C-5149-14-H

Date: October 18, 2010

To: Mr. Eli Ochoa, P. E.
ERO Architects

Re: Structural Investigation of
Partial Collapse of the Main Building
PJSA ISD T-Stem Early College High School
714 E. U.S. Highway 83, Pharr, Texas
FLA 2010.47

SD2

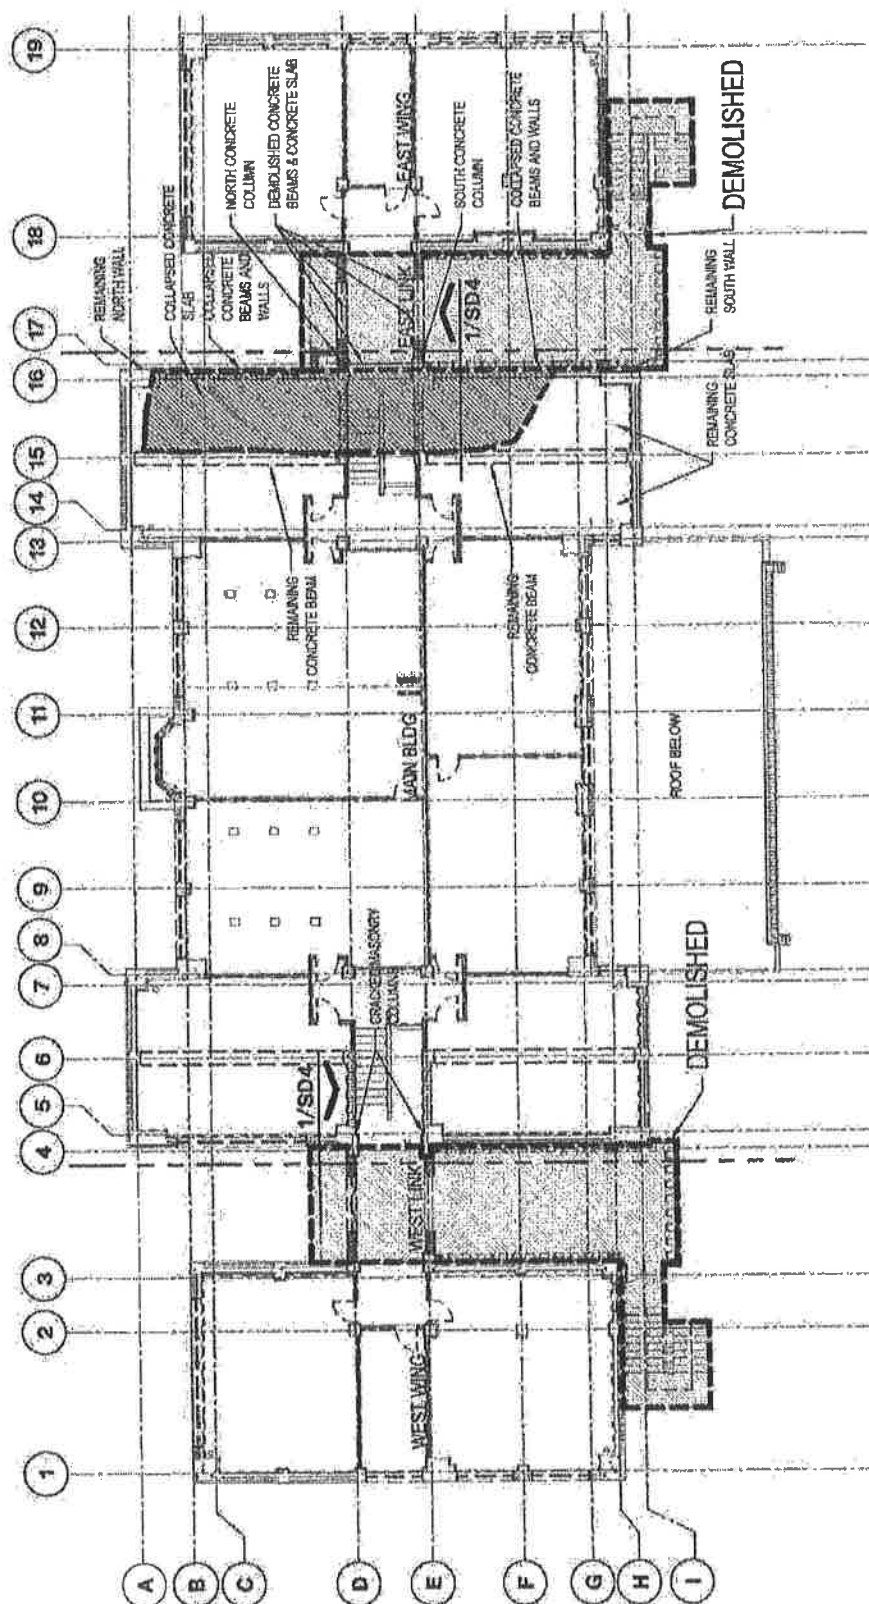
The East Link structure was completely demolished with the exception of some rebar spanning between the buildings. During the demolition of the link, an approximately 12 ft by 60 ft long section of the west side of Main Building was also damaged and collapsed. See plans on drawings SD2 and SD3 and Photos 1 to 17. The collapsed members include the concrete beams and slab at the second floor and roof, load bearing clay tile and brick veneer walls, exterior masonry columns, and concrete masonry unit infill at the wall opening. Part of the second floor and roof slab is still hanging by the rebar and the two wing walls at the north and south of the building are still remaining but have suffered severe damages and separation. The floor and roof beams had rotated and pulled out from the masonry walls, leaving a pocket in the walls. See Photos 2, 11, and 17. It appears that the collapse stops at the first interior beam along Grid 15. See plans on drawing SD2 and SD3.

We recommend that the partially collapsed slab be removed to the face of the beams at the first interior grid line 15. See plan on drawing SD2. The remaining clay tile and masonry walls at the north and south of the building shall be removed to the west of grid 15. New steel structure shall be installed to replace the collapsed slab. Install concrete masonry unit (CMU) wall to the inside of existing wall along grid line A and grid line H and between grid lines 13 and 15 and turn the corners to the masonry columns at B-13

SD4

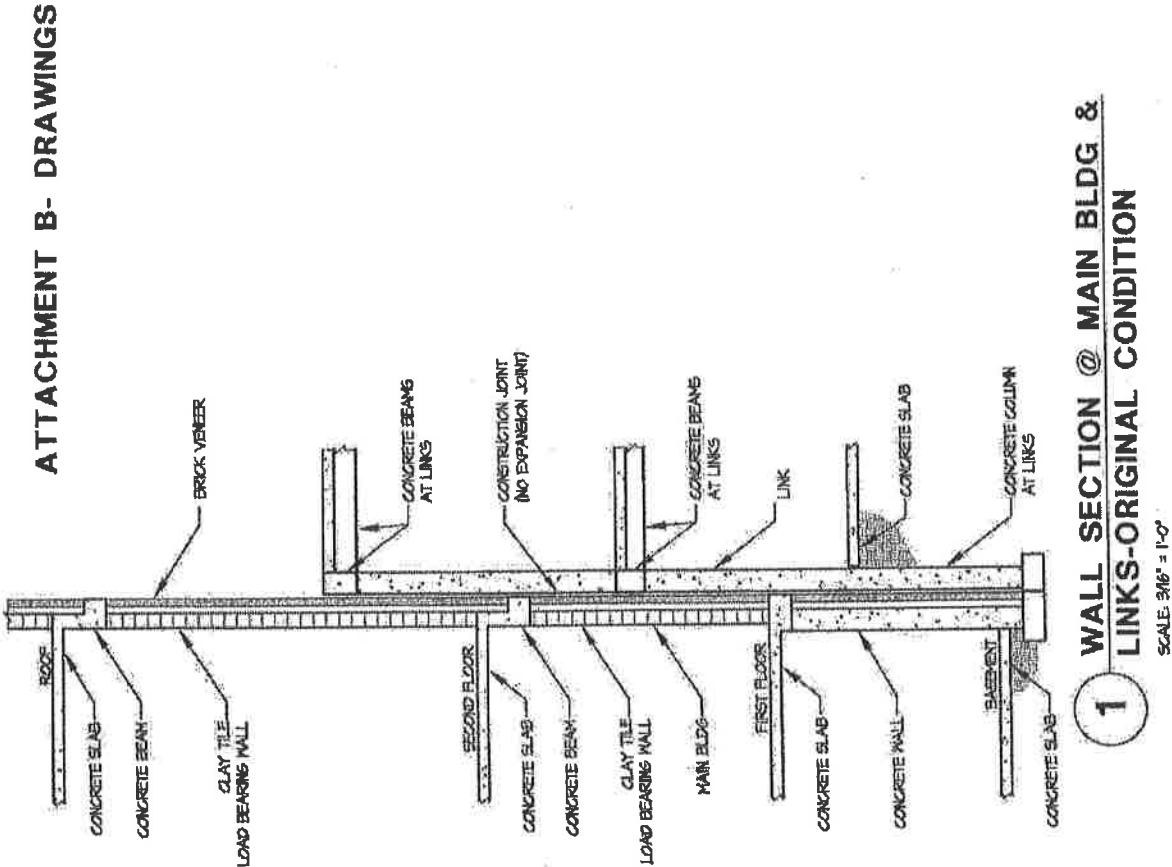
columns and beams poured against and plastered around the existing masonry columns. The masonry columns are part of the load bearing walls supporting the floor and roof of the Main Building. See wall section on attached drawing SD4.

18 - DEMOLISHED CONCRETE FRAME AT WEST LINK & WEST OF MAIN BLDG

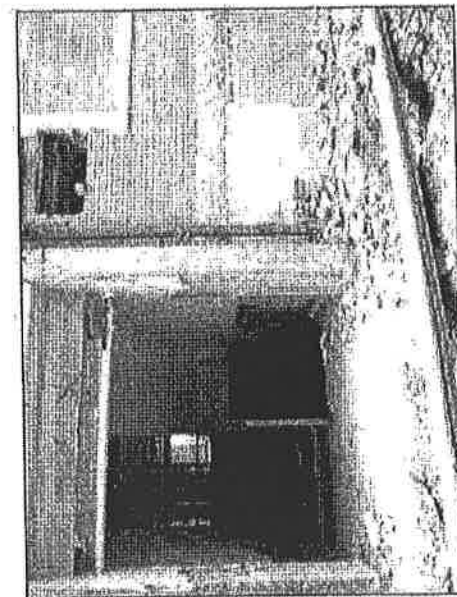
The West Link structure was almost completely demolished except the concrete columns and tie beams attached to the Main Building. See Photos 18, 19, and 20. In general, the masonry walls of the Main Building appear to be in satisfactory condition except at the two hollow masonry columns located at the stair. The masonry columns are sitting on top of concrete columns which are terminated near the floor level. Structural cracks are observed above the concrete columns. See Photos 21 and 22. These cracks and the hollow masonry columns must be addressed prior to future work on the building.

Prior to further demolition, the existing load bearing walls shall be strengthened. We recommend the installation of CMU walls similar to the east side. CMU walls shall be installed along the exterior wall at grid line 5 and turn the corners to grid line 8 along grids A and H. The wall shall terminate at masonry columns B-8 and G-8.
